Access Compliance Report Public Rights-of-Way (Curb Ramps)

Main Street: ANTONIO_PKWY Cross Street: STATION_WAY Location: NE

ADA ID: RPRK211116113756 Ramp Type: Type 1 - Perpendicular Diagonal Initial Pass/Fail: Pass Overall Compliance: No Severity Score: 16

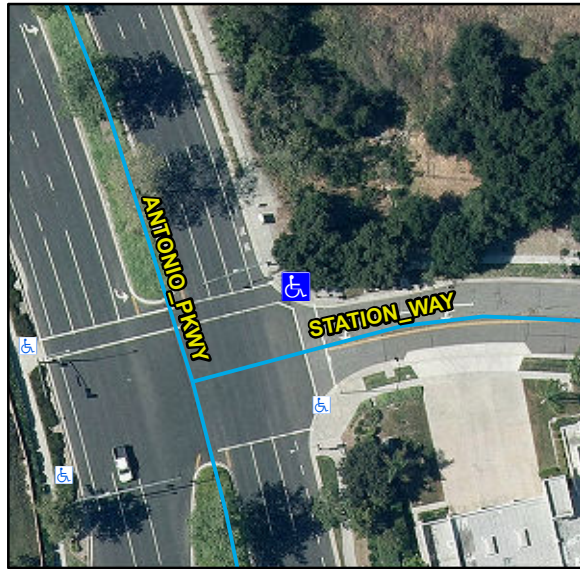
Yes	Ramp Inside Crosswalk 1	Yes	Yes	Ramp Inside Crosswalk 2	Yes
	Crossing 1 Slope (%)	1.5		Crossing 2 Slope (%)	2.2
	Crossing 1 Cross Slope (%)	0.5		Crossing 2 Cross Slope (%)	0.9
Yes	Gutter Ponding	No	Yes	Curb Slope	4.8
Yes	Gutter Lip Height (in)	0		Road Run Slope (%)	1.7
No	Gutter Run Slope (%)	6.1		Road Cross Slope (%)	1.4
Yes	Gutter Cross Slope (%)	1.2			
Yes	Overall Surface Condition: Acceptable		Yes	Perp Joint Present	Yes
	Cross Gutter Present?	No		Spandrel Present?	No
	Replace Cross Gutter?	N/A		Replace Spandrel?	N/A

Remove & Replace Curb Ramp With Two New Directional Ramps or Equivalent. Remove & Replace Gutter.

R304.2.2-Perp, R304.3.2-Para, R304.5.3, R305, R304.5.4, STD 1115
